THE GLIDING FEDERATION OF AUSTRALIA

GFA AIRWORTHINESS DIRECTIVE

SUBJECT: Replacement of the pivot for the rudder drive crank and reinforcement of the rear skid mount.

BULLETIN NO BE-27/KR-03A/93

FIGURE 1
RUDDER DRIVE CRANK 10

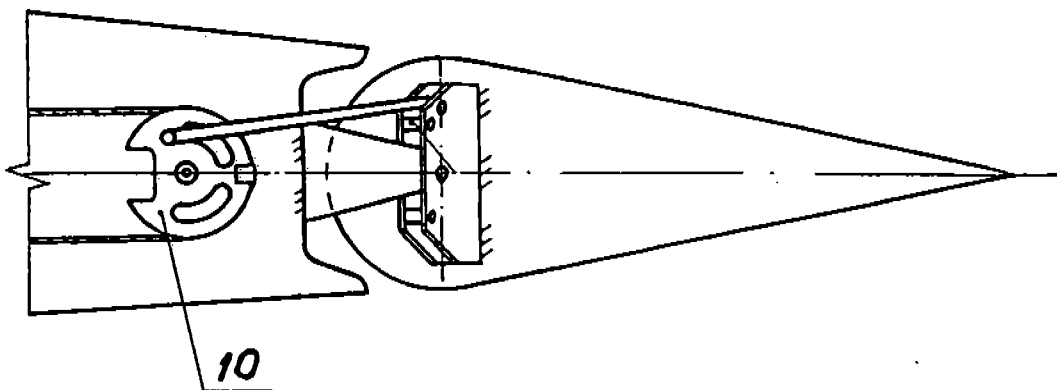
ACTION REQUIRED: Before 30 June, 1994 the pivot for the rudder drive crank (10) must be replaced and the rear skid mount must be reinforced in accordance with the PZL-Krosno bulletin BE-27/KR-03A/93 which forms part of this AD.

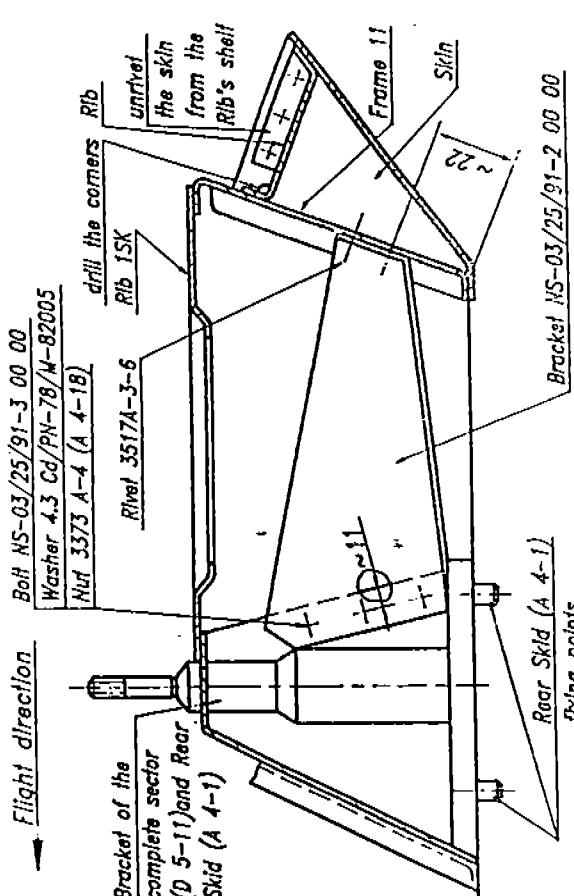
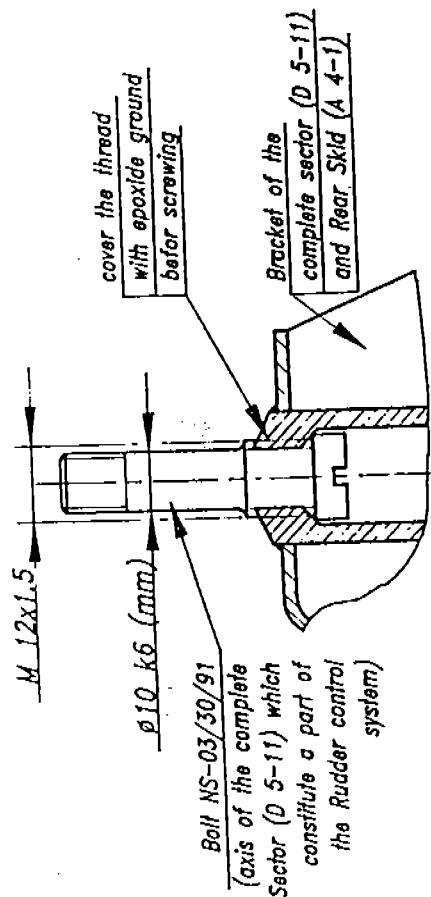
WSK "PZL - Krosno"	BULLETIN NO BE-27/KR-03A/93	Page 4 of 8
resulting from the reaming should be enlarged by means of a drill of dia. 10.5 mm and then threaded M 12 x 1.5. When reaming and threading the LX-KR-5693N guides' set is to be used. All sharp edges are to be taken off. After the thread is covered with an epoxide ground the NS-03/30/91 bolt is to be screwed down to the stop. 4.5. Place the fuselage on supports in flight position. 4.6. Reinforce the rear skid's fixing structure as shown on the sketch.

WSK "PZL - Krosno"	BULLETIN NO BE-27/KR-03A/93	Page 3 of 8
4.2. Disconnect the Complete Cable (D5-8) and Special Push Rod (D5-12) from the Complete Sector (D5-11) 4.3. Turn the fuselage upside-down (by 180°) and place it on supports. 4.4. Following the below mentioned procedure and the sketch, replace the bolt with the new one without dismounting the Complete Sector's (D5-11) fitting and Rear Skid (A4-1) from the fuselage structure.  The old bolt should be removed by reaming with a drill of dia. 6 mm starting from the rear skid side. The hole

WSK "PZL - Krosno"	BULLETIN NO BE-27/KR-03A/93.....	Page 5 of 8
The reinforcement consists in fixing the NS-03/25/91-2.00.00 Bracket to the structure in the rear skid area. In order to have access to fix the bracket to Frame 11 the skin should be unriveted from the shelf of the rib (see sketch). Before bending the Rib upside, the corners are to be drilled with a drill of dia. 4 mm. The Bracket is to be put in throughout the hole of the Rib 1SK. After the reinforcement is completed the Frame is to be riveted to the skin again by means of repair rivets 3549-3.5-6. Make finishing touches with a paint. 4.7. Put the Complet Sector AB.53.008.00.02 (D5-25) instead of the AB.53.008.00.01 (D5-11) one using the Special Push Rod (D5-12) previously taken down from the Complet Sector (D5-11). The nut, fitting the bolt, is to be safeted against unscrewing by pricking (punching) in four places. The Complet Cable (D5-8) and Special Push rod (D5-12) are to be fastened to the Complet Sector as it was done previously, using the same fixing elements. Split pins and self-locking nuts are to be replaced with new ones.
